**RE: Response Letter Regarding
COM Comments for the
Stratmoor Hills Water District CSU Interconnection Modifications Project**

STRATMOOR HILLS WATER DISTRICT – CSU INTERCONNECTION MODIFICATIONS

CSU INTERCONNECTION MODIFICATIONS

SITE PLAN

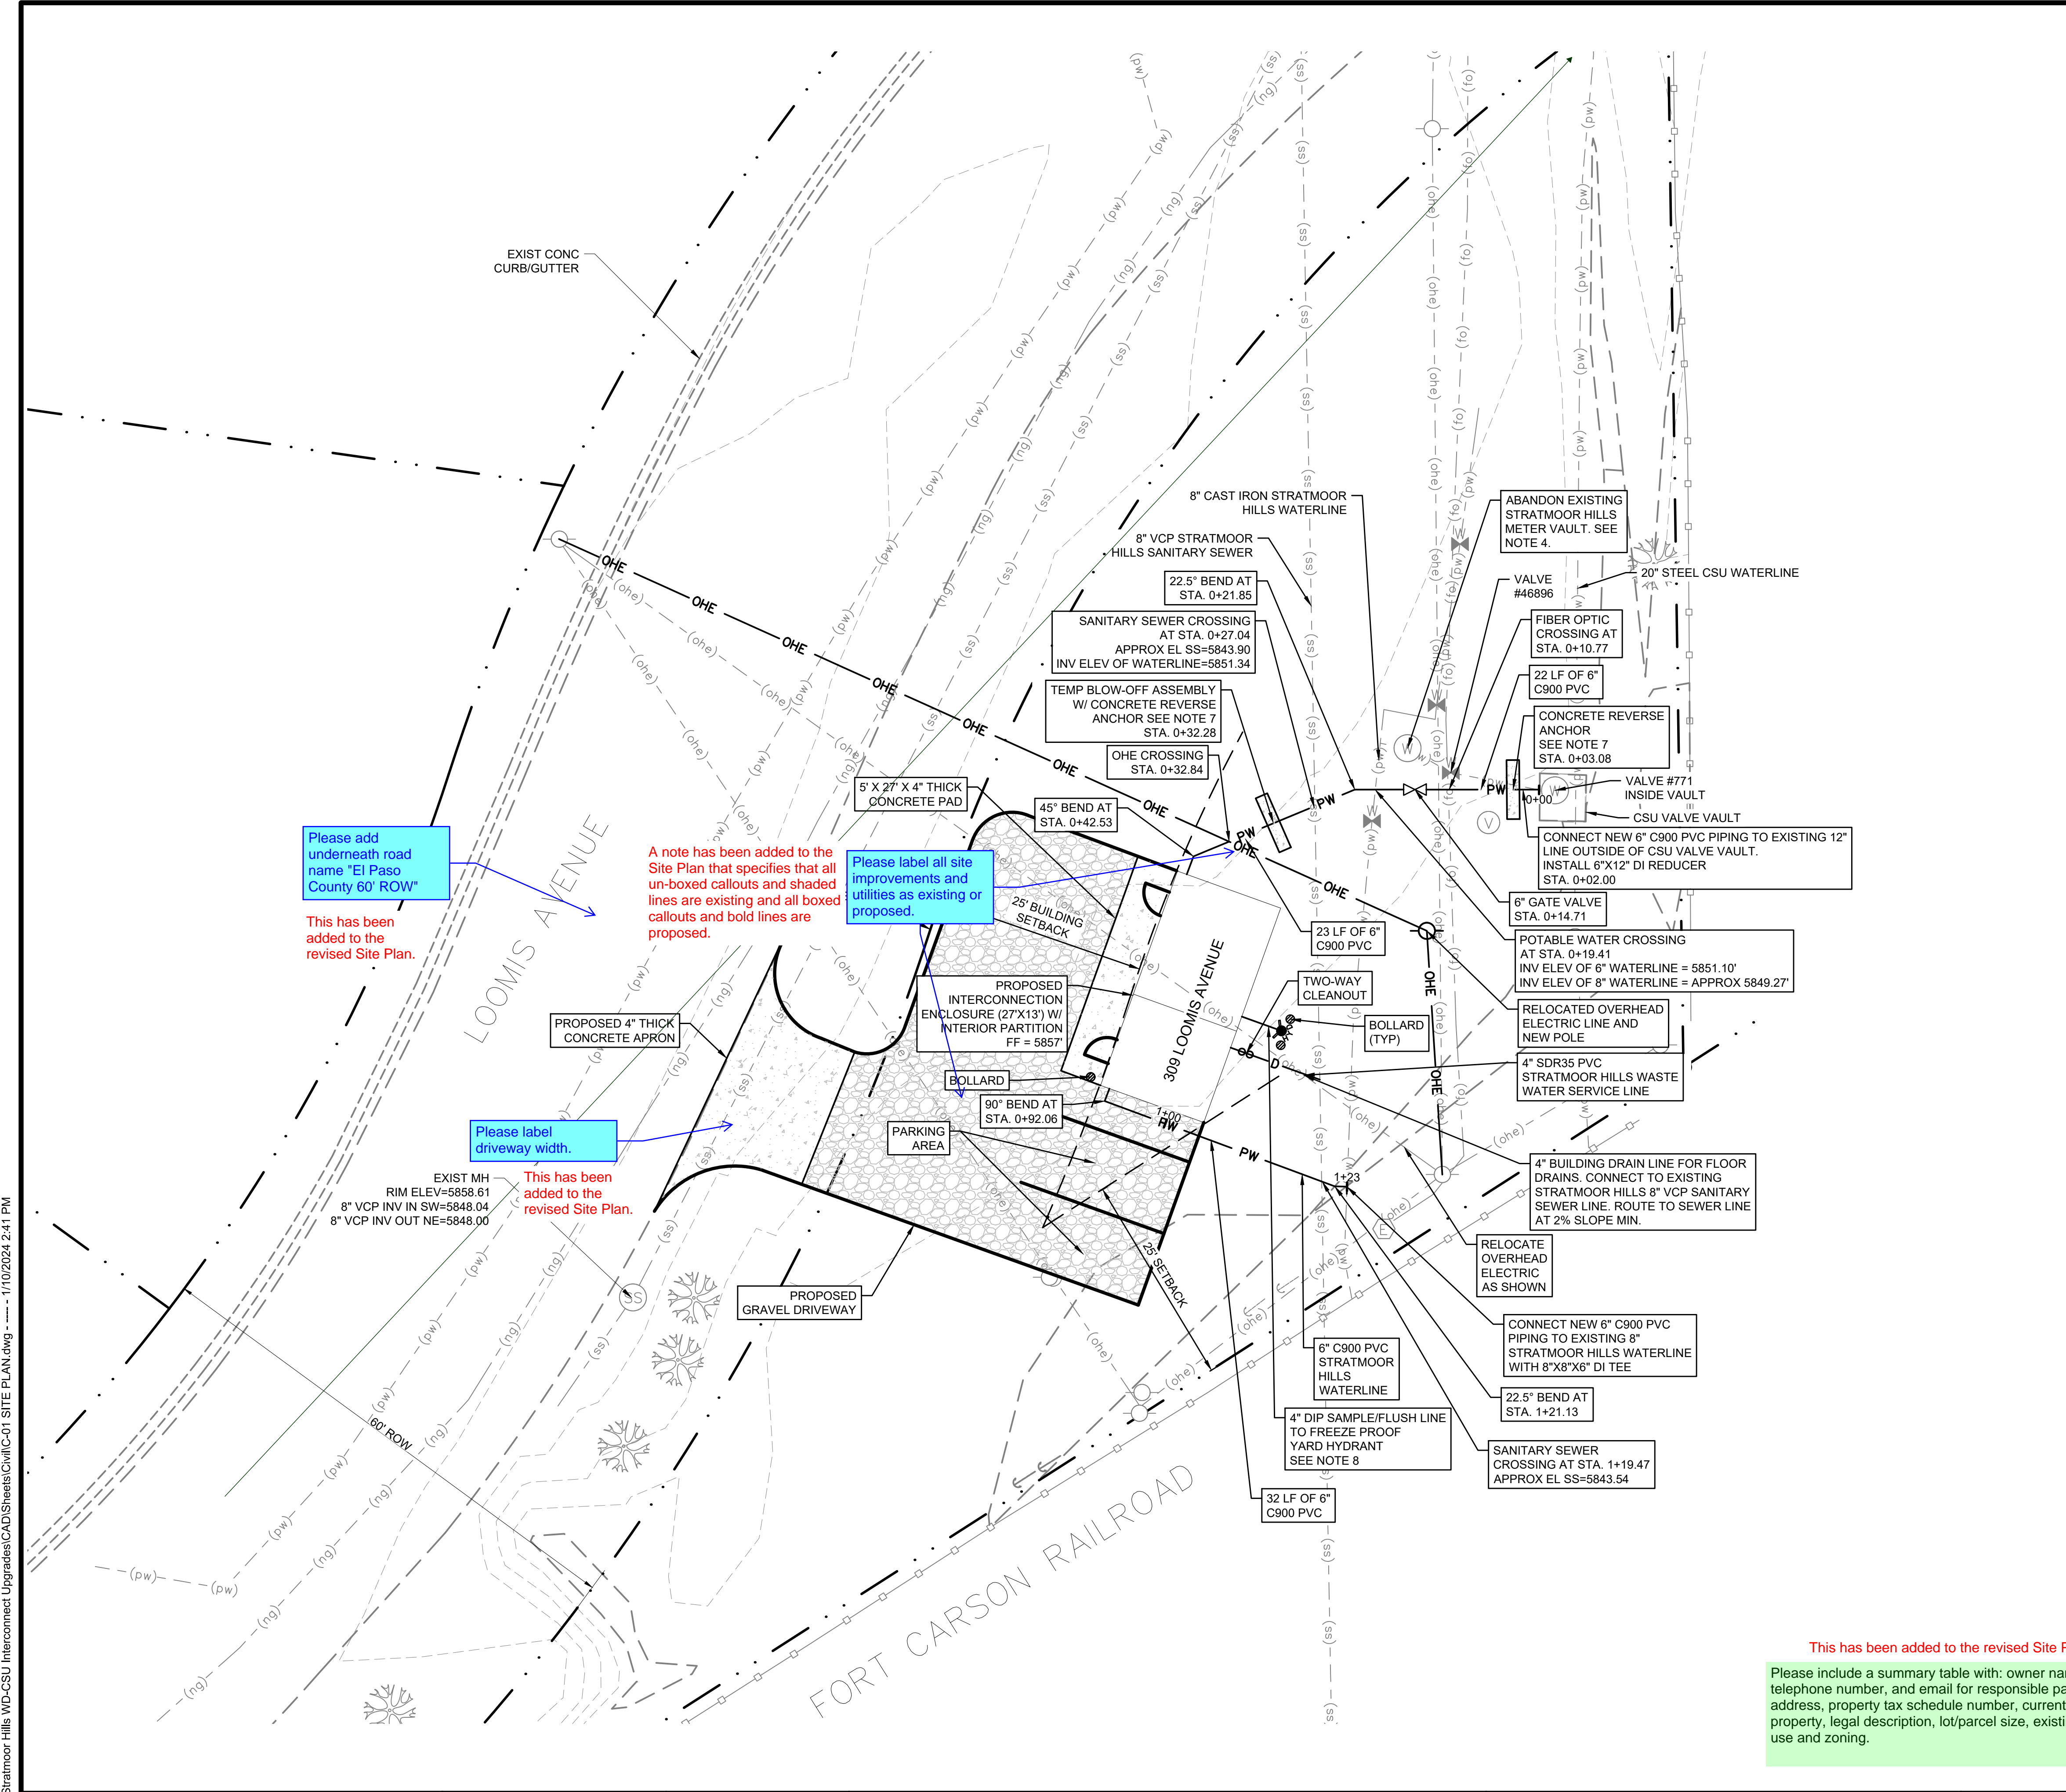
Please add underneath road name "El Paso County 60' ROW"

Please label all site improvements and utilities as existing or proposed.

Please label driveway width.

Please add "PCD File No. COM2323"

Please remove

This has been added to the revised Site Plan.

A note has been added to the Site Plan that specifies that all un-boxed callouts and shaded lines are existing and all boxed callouts and bold lines are proposed.

This has been added to the revised Site Plan.

This has been added to the revised Site Plan.

This has been removed from the revised Site Plan.
